## Access Compliance Report Public Rights-of-Way (Curb Ramps)

Intersection ID: 10655 Main Street: BELLE\_PLAINE\_DR Cross Street: MILTON\_RD Location: N

ADA ID: 73F6CB6871F1 Ramp Type: PerpDiag Initial Pass/Fail: Fail Overall Compliance: No Severity Score: 18.75

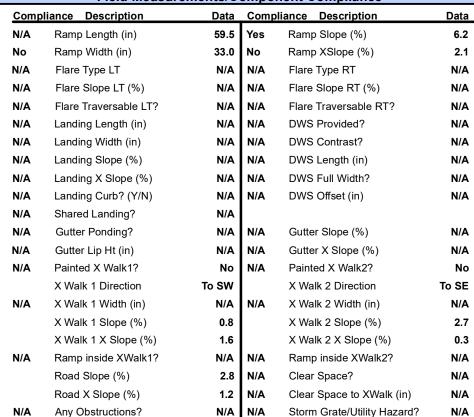
Not Found, R304.5.1, R304.5.3

Remove & Replace Curb Ramp With Two New Directional Ramps or Equivalent.
